Access Compliance Report

Public Rights-of-Way

(Curb Ramps)

Intersection ID: 43674	Main Street: ARMOUR RIDGE DR	Cross Street: ASHETON CREEK DR	Location: S
ADA ID: 1EA47AC1CE7A	Ramp Type: PerpDiag	Initial Pass/Fail: Fail	Overall Compliance: No
Codes/Mitigation Info/Possible Solution		Field Measurements/Component Compliance

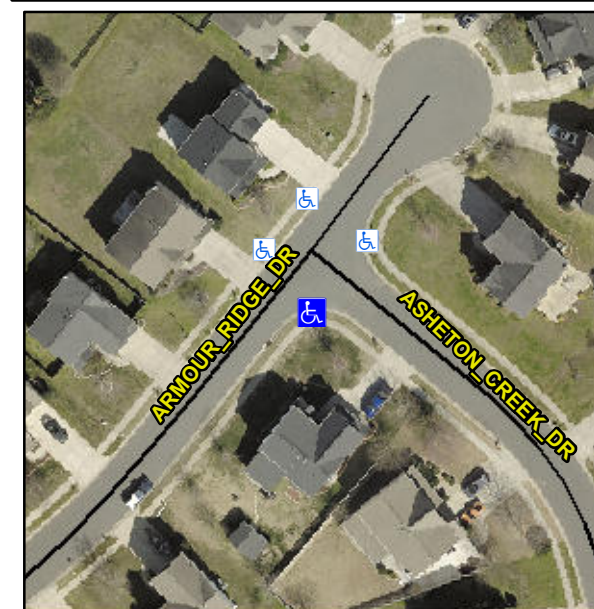
Not Found, R304.2.2, R304.5.3

Compliance	Description	Data	Compliance	Description	Data
N/A	Ramp Length (in)	46.0	No	Ramp Slope (%)	9.7
Yes	Ramp Width (in)	48.0	No	Ramp XSlope (%)	2.3
N/A	Flare Type LT	N/A	N/A	Flare Type RT	N/A
N/A	Flare Slope LT (%)	N/A	N/A	Flare Slope RT (%)	N/A
N/A	Flare Traversable LT?	N/A	N/A	Flare Traversable RT?	N/A
N/A	Landing Length (in)	N/A	N/A	DWS Provided?	N/A
N/A	Landing Width (in)	N/A	N/A	DWS Contrast?	N/A
N/A	Landing Slope (%)	N/A	N/A	DWS Length (in)	N/A
N/A	Landing X Slope (%)	N/A	N/A	DWS Full Width?	N/A
N/A	Landing Curb? (Y/N)	N/A	N/A	DWS Offset (in)	N/A
N/A	Shared Landing?	N/A			
N/A	Gutter Ponding?	N/A	N/A	Gutter Slope (%)	N/A
N/A	Gutter Lip Ht (in)	N/A	N/A	Gutter X Slope (%)	N/A
N/A	Painted X Walk1?	No	N/A	Painted X Walk2?	No
	X Walk 1 Direction	To NE		X Walk 2 Direction	To NW
N/A	X Walk 1 Width (in)	N/A	N/A	X Walk 2 Width (in)	N/A
	X Walk 1 Slope (%)	3.1		X Walk 2 Slope (%)	4.0
	X Walk 1 X Slope (%)	0.4		X Walk 2 X Slope (%)	2.4

Remove & Replace Curb Ramp With Two New Directional Ramps or Equivalent.
